# Warren Village Traffic Calming

## Striping Layout for Review

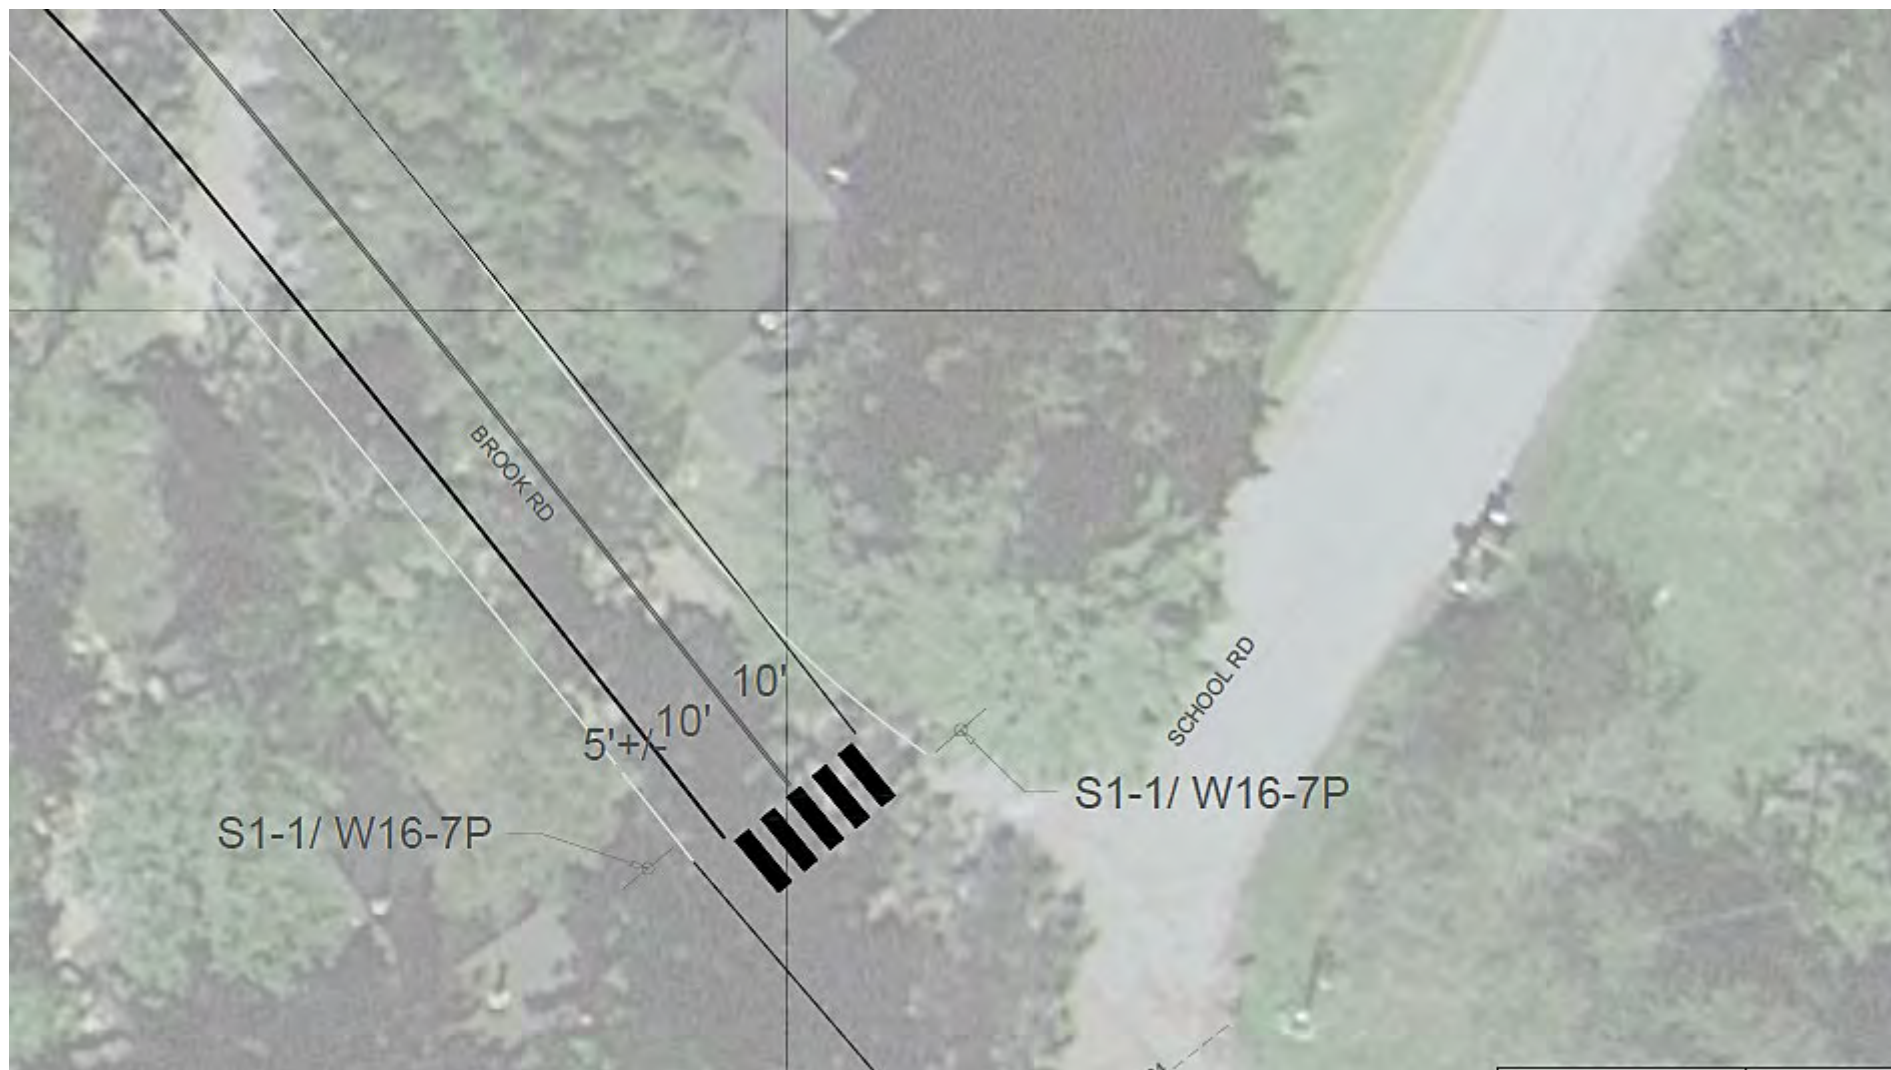
North end of Flat Iron Rd with stop bar moved, crosswalk painted and 6 ft path on South side of Flat Iron and 1' shoulder on North side, and a single 12' travel lane.

Speed reduction delineators on downhill lane of Brook Road staring at radar sign

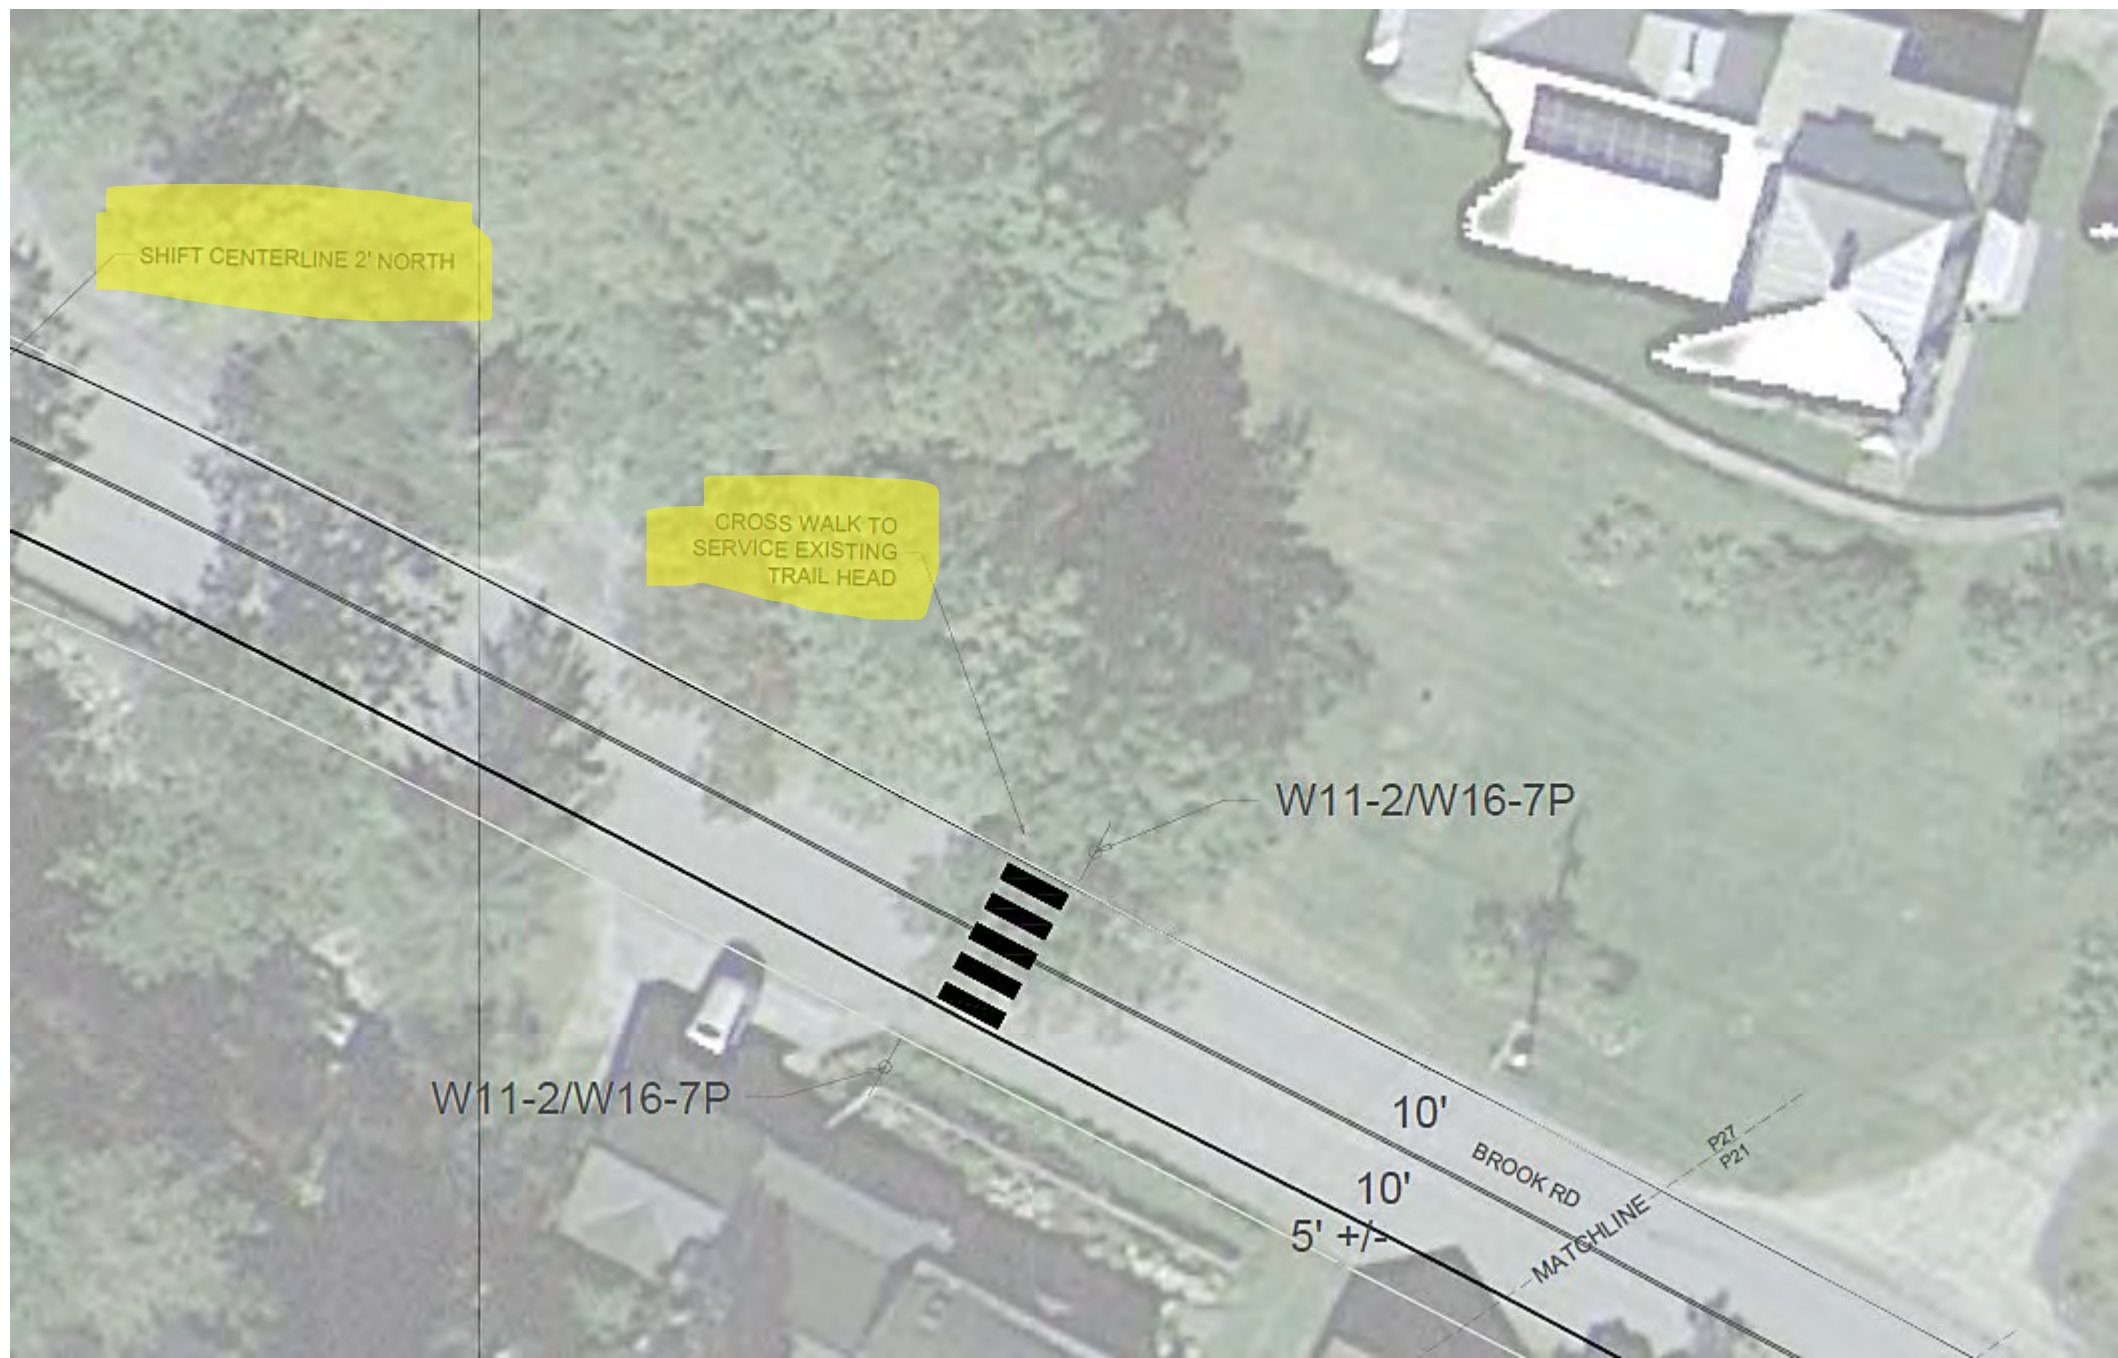
Previous slide and this slide show a walking lane on West side of the Southern part of Main Street from Rt 100 to Bridge Street – it would require grinding off the center line and narrowing the travels lanes to 10 feet.

Do we want to do?
